Ouray Planning Commission Special  
Meeting  
Tuesday, May 23, 2023 6:00 PM

**TO:** Ouray Planning Commission  
**FROM:** Lily Oswald, Community Development Director  
**FOR:** May 23, 2023  
**SUBJECT:** Waterview PUD – Preliminary Plat Application Staff Report

<b>Application Summary</b>	This Preliminary Plat Planned Unit Development (PUD) is for residential development on two (2) vacant lots north of the Biota Building. The general intent of the PUD is to develop 65 affordable, owner-occupied residential units via single-family homes, duplexes, and triplexes with (3) in-unit home childcare opportunities in the first phase. <i>This PUD is proposed in two (2) phases of development to align with the City’s Waste Water Treatment Facility upgrade – both phases are included in the Sketch Plan application. This application is proposed from Rural Homes, LLC, and refers to this project as the “Waterview PUD.”</i>	
<b>Address</b>	250 Uncompahgre Street	
<b>Parcel Number(s)</b>	451725113001 and 451725113002	
<b>Legal Description</b>	Subd: Ouray Waterview Subdivision Lot 2 Lot Split Lot: 2A S: 25 T: 44 R: 8; and Subd: Ouray Waterview Subdivision Lot 2 Lot Split Lot: 2B S: 25 T: 44 R: 8

Sheet  
**G1.01**  
COVER SHEET

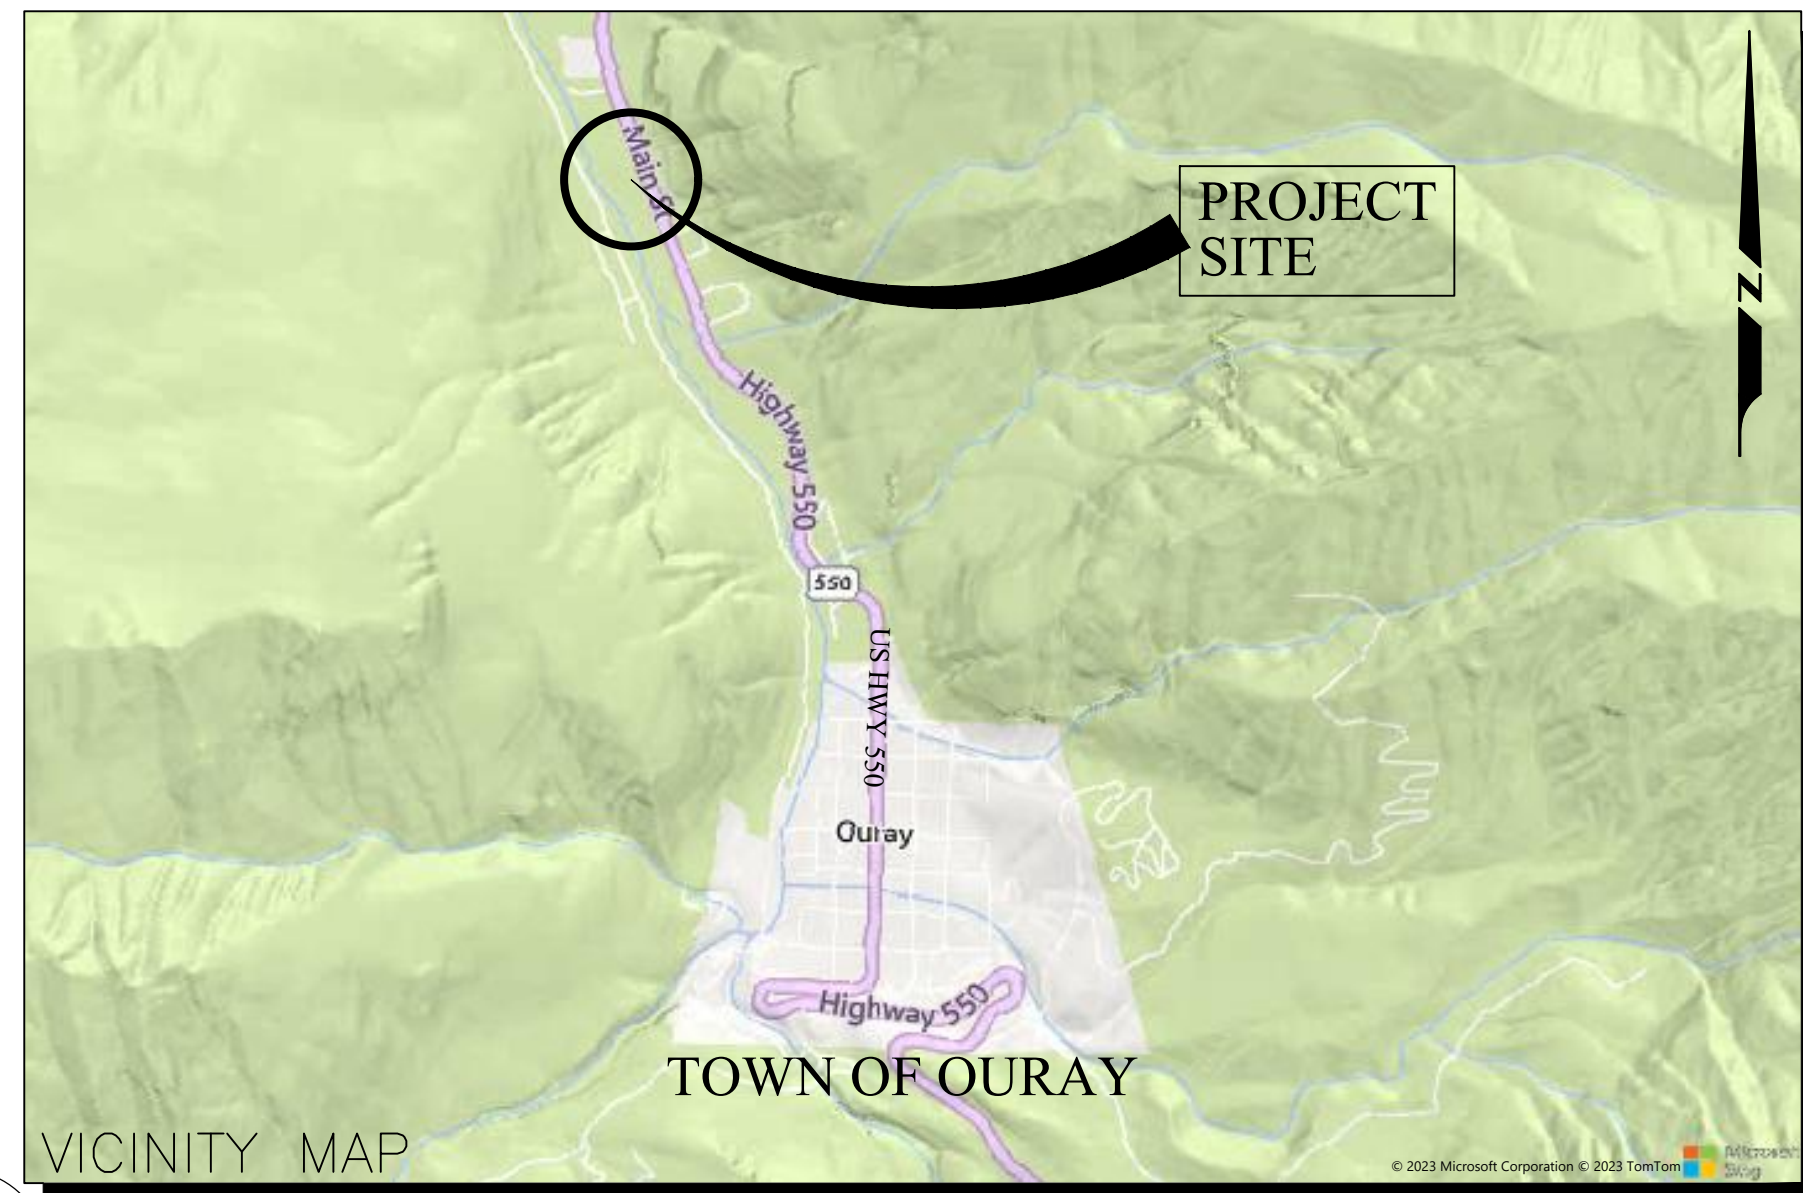
2. Correct all titles of documents to reflect “City of Ouray” not “Town of Ouray.”
  - a. *Example: engineered construction cover sheet.*
3. Correct all documents to reflect “Uncompahgre Street” and “Uncompahgre River” where mislabeled.
